# Access Compliance Report

## Public Rights-of-Way

Intersection ID: 10027409	Main Street: GOLF_ACRES_DR	Cross Street: N/A	Location: NW
ADA ID: 688D1F85EE08	Ramp Type: Combination2Diag	Initial Pass/Fail: Fail	Overall Compliance: No
		Severity Score: 0

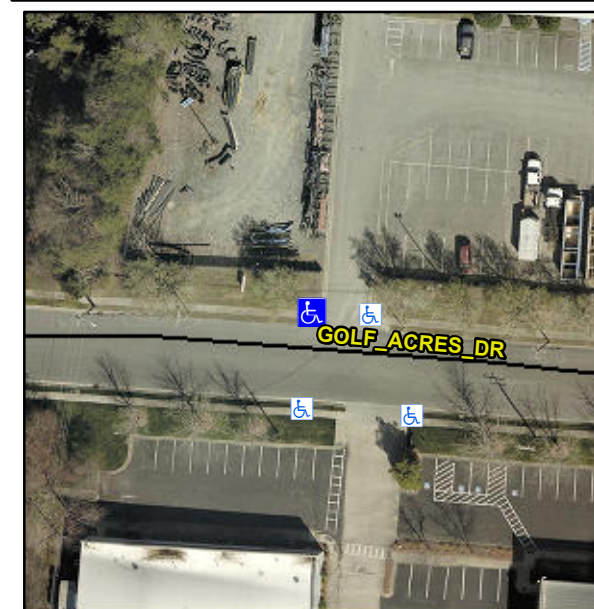
**Remove & Replace Curb Ramp With Two New Directional Ramps or Equivalent.**

**R304.5.1, R304.5.3, R304.3.2**
